Service Bulletin

Bulletin No: JC-023-12

Product Type: G, H & J series BOB-CAT mowers

Cut Quality and Optimal Blade Pitch Setting

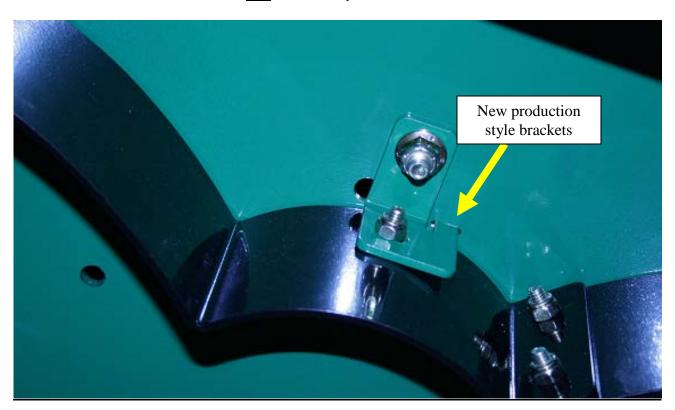
Cause: It's possible with variances in production tolerances that the front deck baffles can be positioned too far from the leading edge of the blade. This can reduce the lift and efficiency of the cutting system and impact the quality of cut in some applications.

Action Required: Follow the instructions in kit (see below for kit numbers) to install adjustable mounting brackets to position baffles within 1/4" of the blade (a typical instruction sheet is attached at the end of this bulletin). New production units will have mounting brackets that will be indexed to the deck to insure accurate baffle positioning. Units that have brackets with locator tabs as shown below are **not** affected by this bulletin.
